Maughanaclea Wind Farm Observation

Case reference: PAX04.324165

Description: 10-year planning permission for Maughanaclea Wind Farm consisting of 14 no. wind turbines, a 110kV substation and 110kV underground cabling connection and associated works by Maughanaclea Ltd

Focused extract of map from EIA showing incorrect water course, location of houses and estimated actual water course

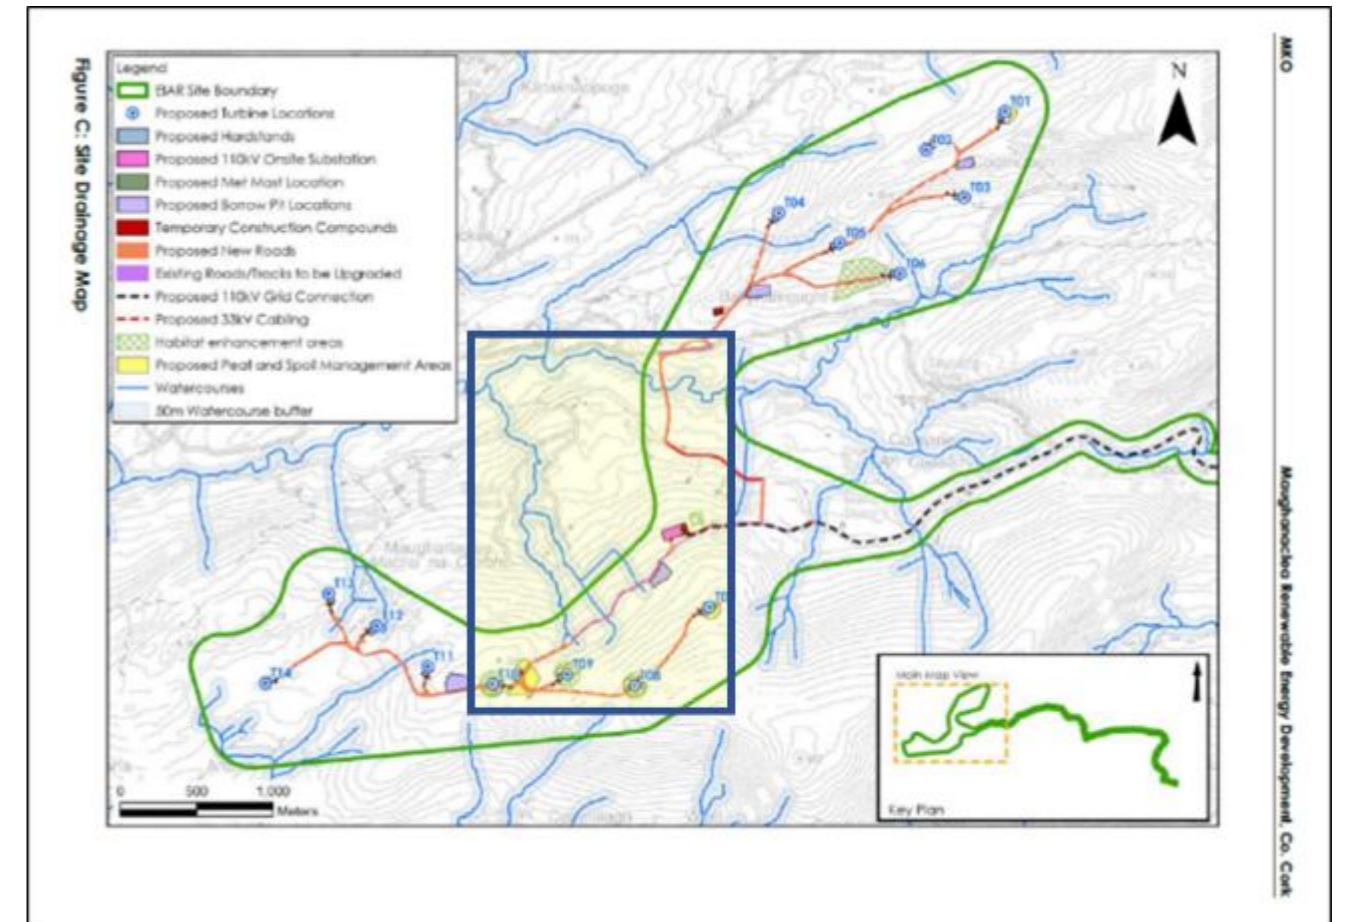
Chapter 9 of the Environmental Impact Assessment Report (EIA) and the accompanying Flood Risk Assessment (Appendix 9-1) are founded on an incorrect identification and mapping of a watercourse, which constitutes a material defect in the hydrological baseline and undermines the reliability of the flood risk assessment and proposed mitigation measures.

Page 15 of Appendix 9-1 (Flood Risk Assessment) incorrectly describes a watercourse as a tributary of the Maughanaclea River. This description is factually incorrect. Based on the on-the-ground hydrology, the watercourse:

The focused mapping extract within the EIAR further highlights this discrepancy. The watercourse alignment shown in Appendix 9-1 does not correspond with the watercourse as it exists on the ground.

This misidentification of the receiving watercourse results in an incorrect catchment delineation, which directly affects the hydrological assumptions underpinning the Flood Risk Assessment (Appendix 9-1).

Focused extract of map from EIAR showing incorrect water course, the estimated actual water course and photograph locations

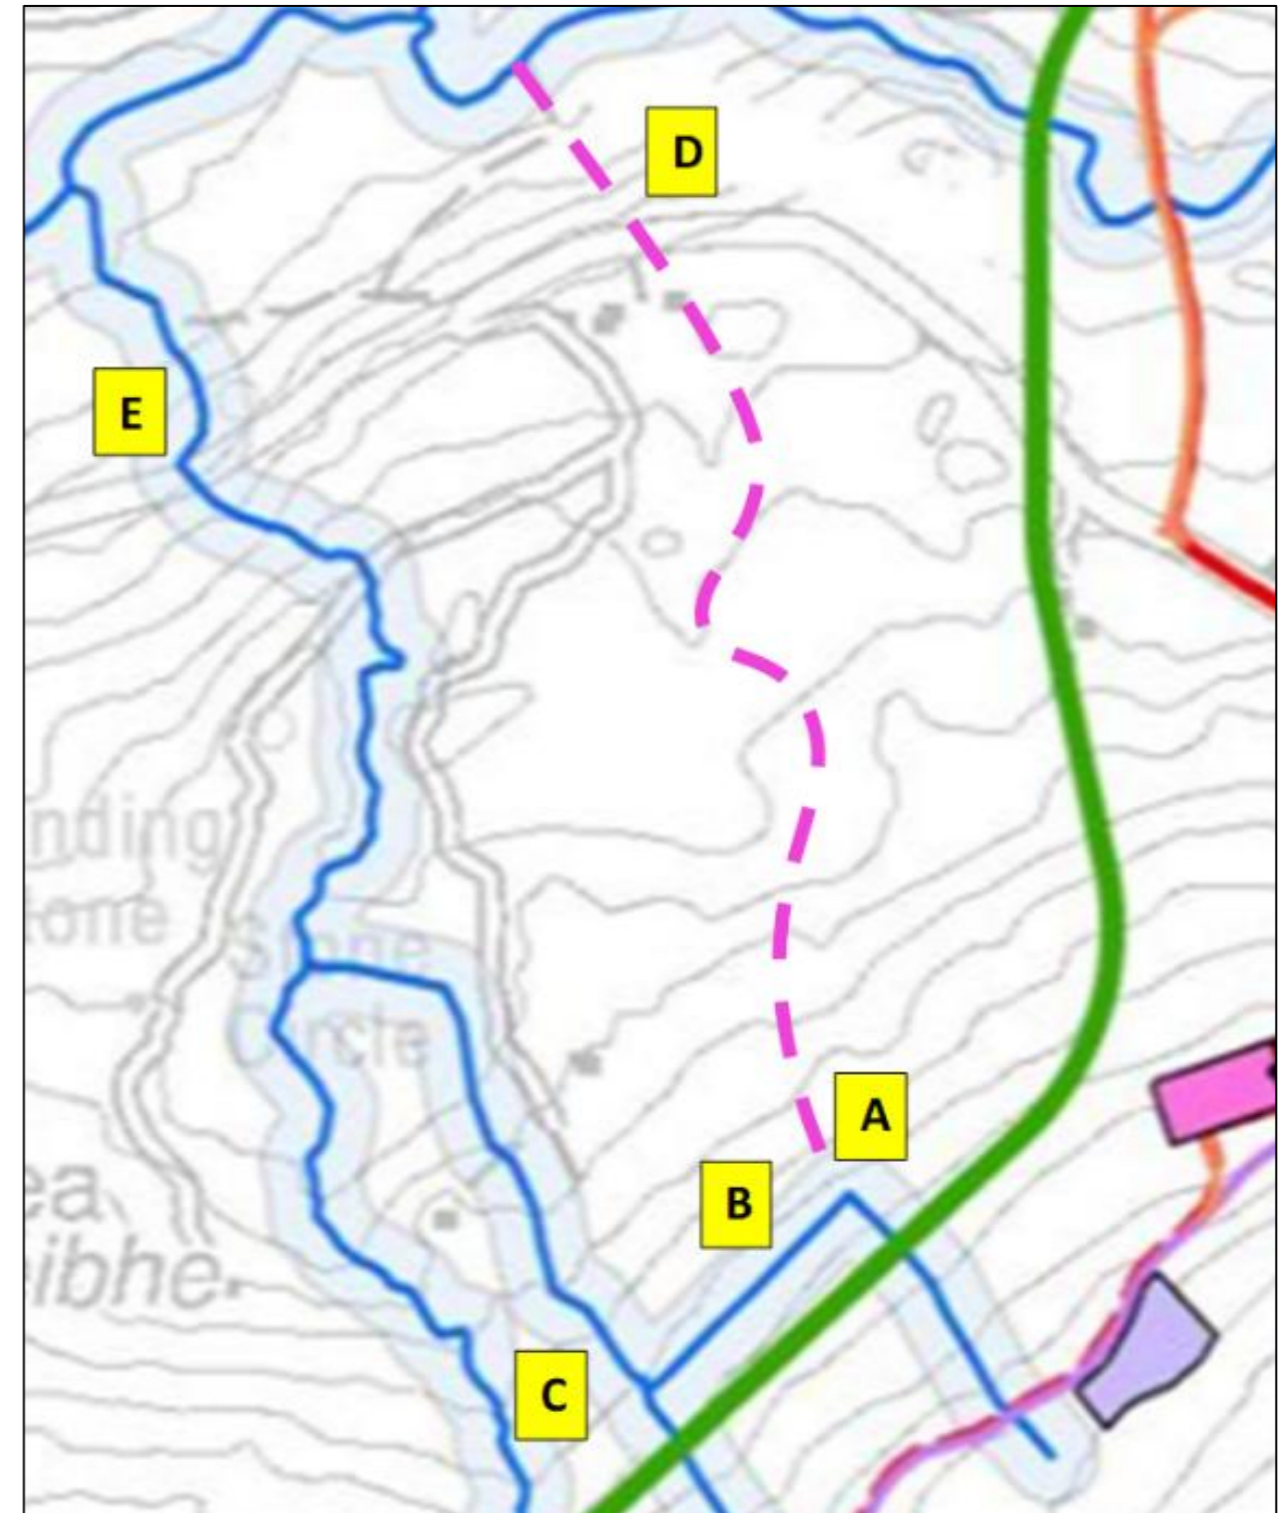
Locations A and D identify a watercourse that has been omitted from the Flood Risk Assessment, despite the fact that it would be required to convey storm overflow and surface runoff from the proposed development; no flood risk or capacity assessment has been undertaken for this river by the applicant's consultants. The watercourse between Points A and D passes in close proximity to three residential dwellings and crosses the R585 regional road, giving rise to a clear potential risk to property, road safety and infrastructure during extreme rainfall events.

The absence of any assessment of flood risk along the full course of this river represents a serious omission and **calls into question the accuracy and reliability of the flood risk assessment and hydrological modelling elsewhere within the project**, a concern compounded by elevation data shown in the accompanying image which suggests **sections of the river FLOWING UPHILL**, indicating likely errors in watercourse identification, elevation modelling, or interpretation of topographical data.

Elevations of points on incorrect leg of water course suggesting water would flow up hill.

Private Well at my Property

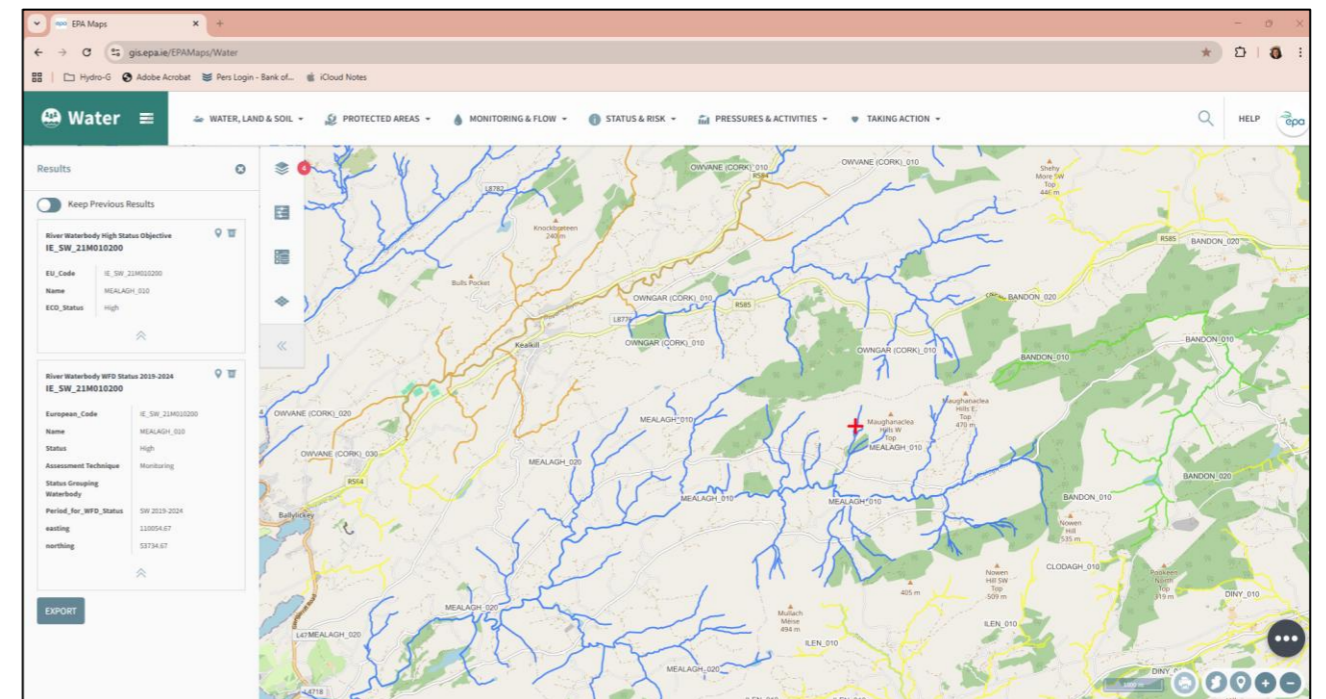
I have serious concerns regarding the potential impact of this development on my private groundwater well. The EIAR acknowledges that the database of private wells is incomplete; however, no field survey or direct identification of wells appears to have been undertaken, notwithstanding recommendations from the HSE. The assessment instead relies on assumptions regarding groundwater flow and separation distances, rather than on site-specific evidence, and no baseline testing of private wells has been carried out. In the absence of such baseline data, there is no reliable mechanism to detect, attribute, or remediate any potential impacts on water quality or supply.

On that basis, can the applicant demonstrate how it has adequately identified, assessed and mitigated potential risks to private groundwater supplies, and, if such demonstration has not been clearly provided, can the applicant be required to undertake a comprehensive field survey of private wells, baseline water quality testing, a detailed site-specific hydrogeological assessment, and the preparation of a robust monitoring and contingency plan, prior to the determination of this

Locations of Turbines T07 to T14 relative to my house.

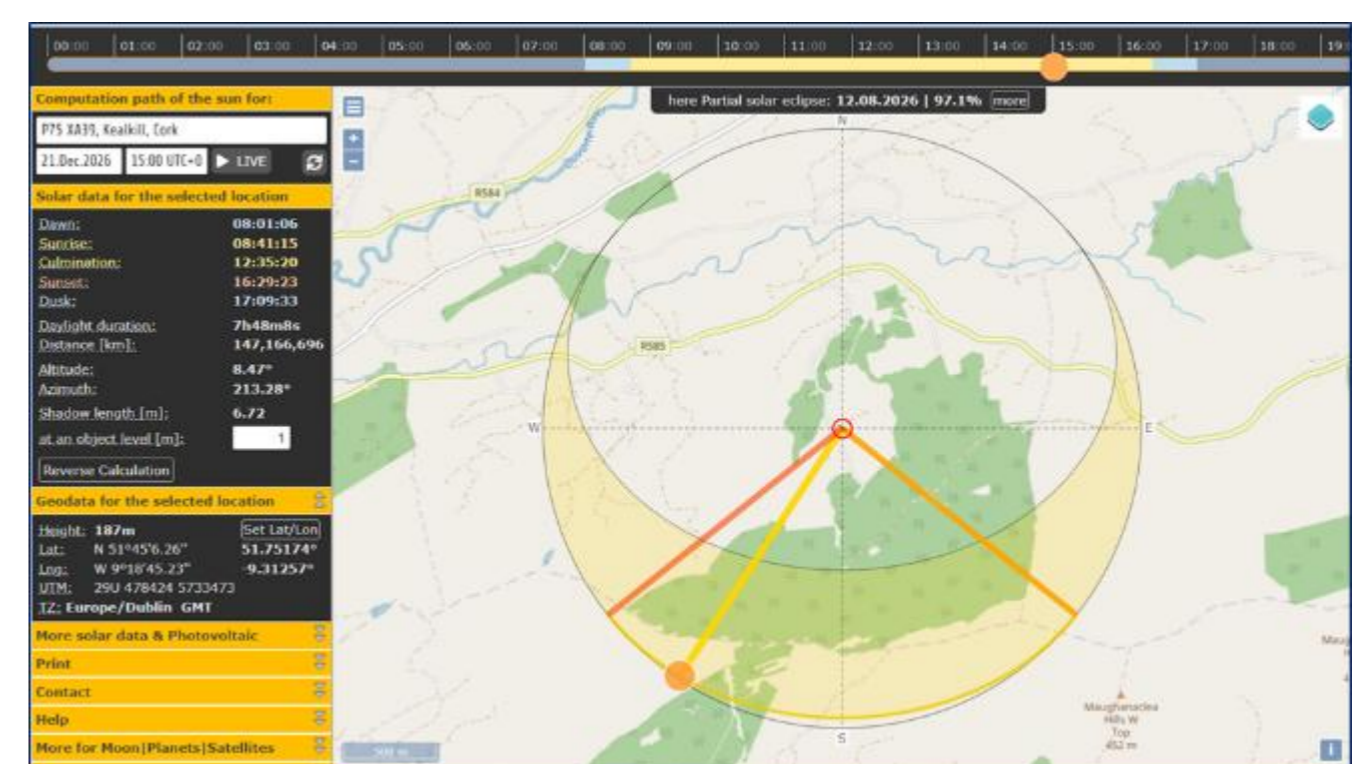
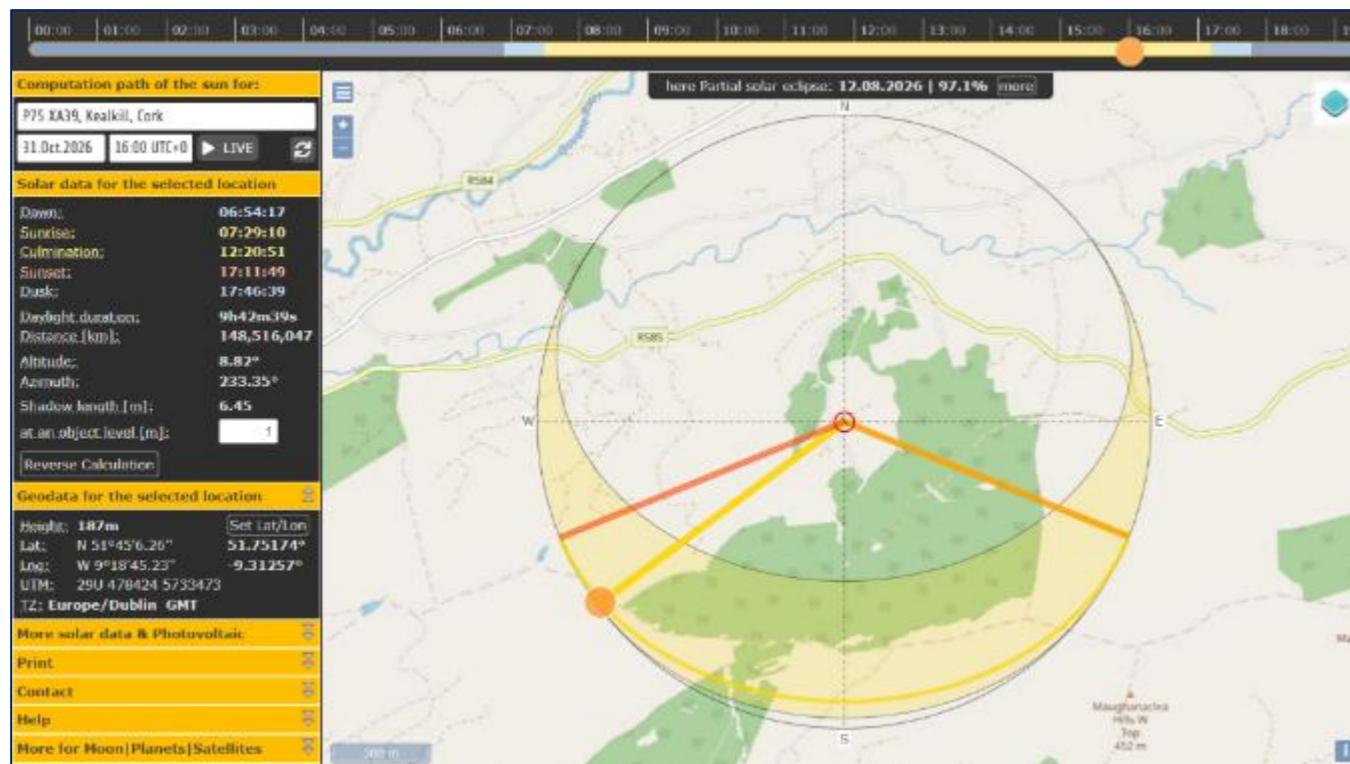
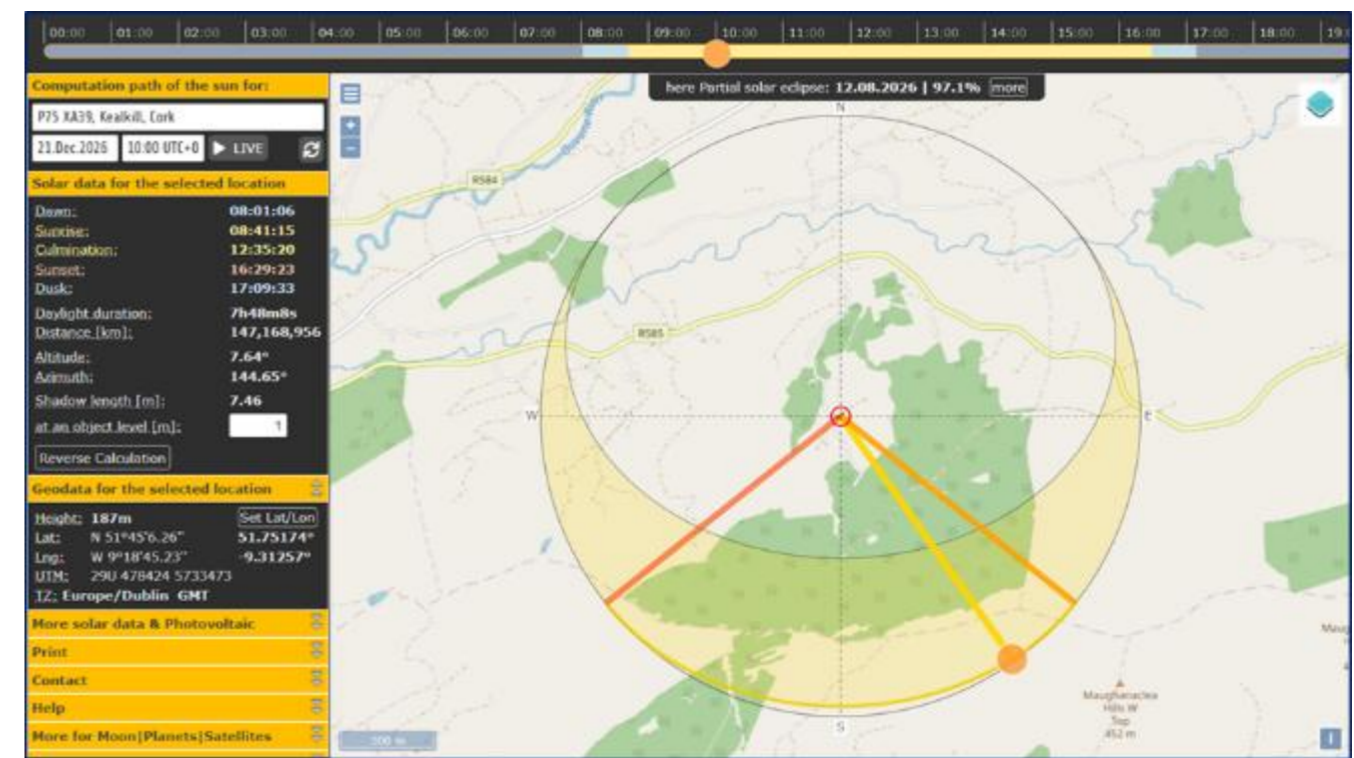
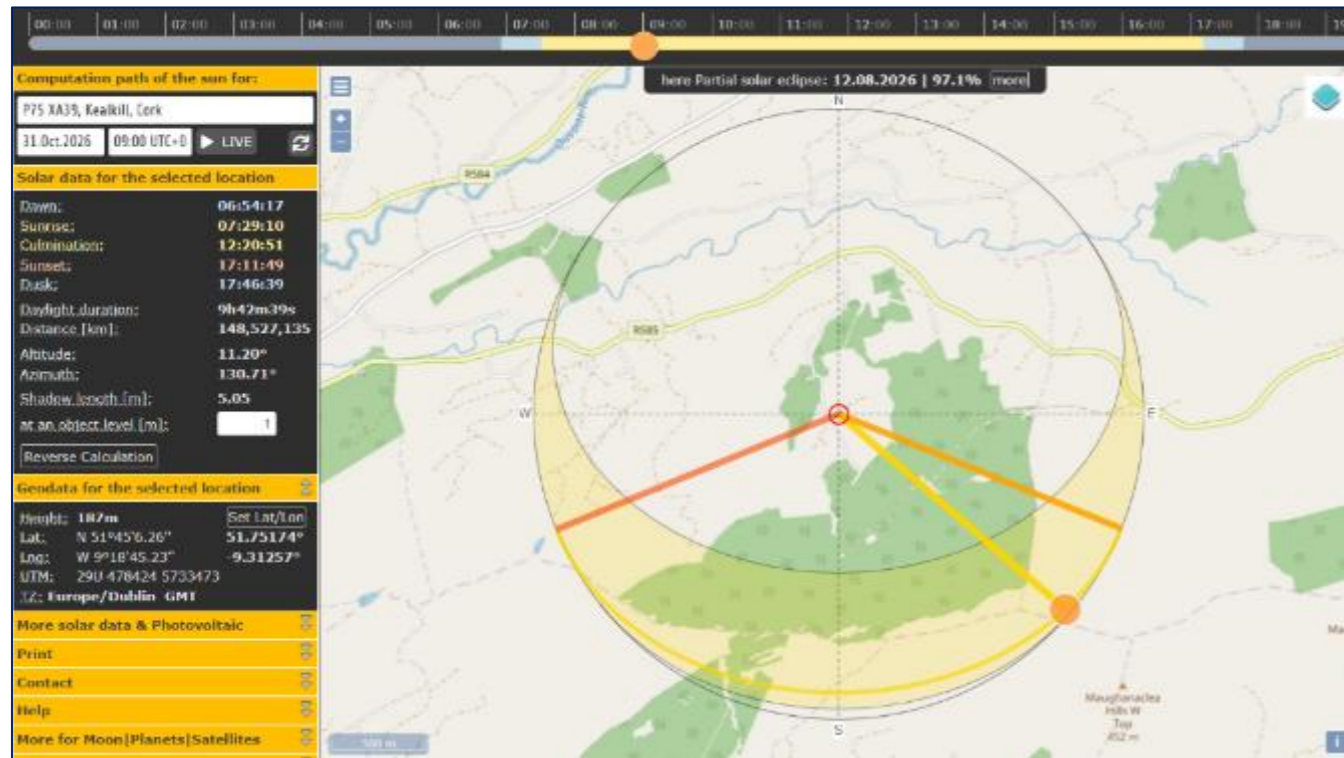
In these circumstances, can the applicant be required to undertake a revised and comprehensive cumulative shadow flicker assessment, incorporating all contributing turbines (T07–T14), supported by site-specific verification, seasonal solar modelling, and worst-case scenario analysis, including a clear breakdown of daily and seasonal exposure levels?

In the absence of such revised assessment, can the Board confirm on what evidential basis it can reasonably rely on the stated post-mitigation exposure of 28 minutes per annum as a robust, accurate and representative assessment of actual conditions, and that an unacceptable loss of residential amenity will not arise?
